3070-73-S

S E R V I C E N O T E

Agilent 3070 Board Test Systems

POSSIBLE ELECTRICAL SHOCK HAZARD

Figure 1. Cable harness side of the MPU.

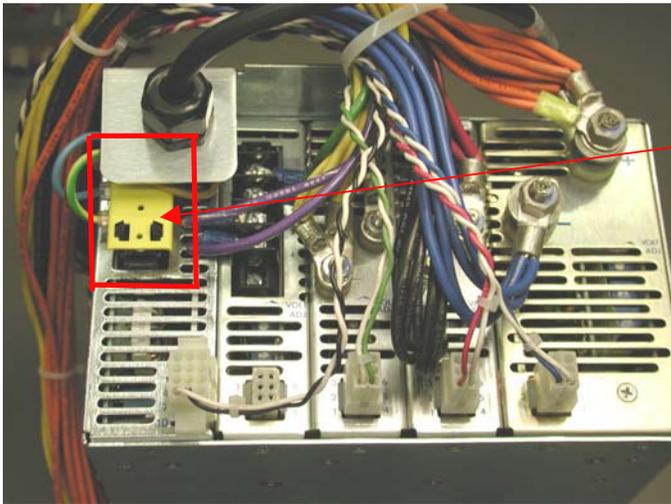
The E4000-69203 and the E4000-69213 MPU's may have been returned from our vendor's repair center without the AC Safety Cover being installed. The MPU's should be inspected to determine whether the AC Safety Cover was installed.

- 1) Shutdown the 3070 using the standard operating procedures.
- 2) Lock Out / Tag Out the 3070 by locking the mains disconnect device in the "off" position before proceeding with this procedure.
- 3) Inspect each MPU in the Agilent 3070 system to verify that the AC Safety Cover has been installed. The AC Safety cover is located at one end of the MPU by the cable harness.
See Figure 1 and Figure 2.
- 4) If the AC Safety Cover is missing, order one from GTLS and install on MPU.
- 5) Record MPU serial number and whether or not the AC Safety Cover was installed.
- 6) Email the MPU Serial numbers to: "MTBUSERVICENOTES@agilent.com"

Yellow AC Safety Cover Installed
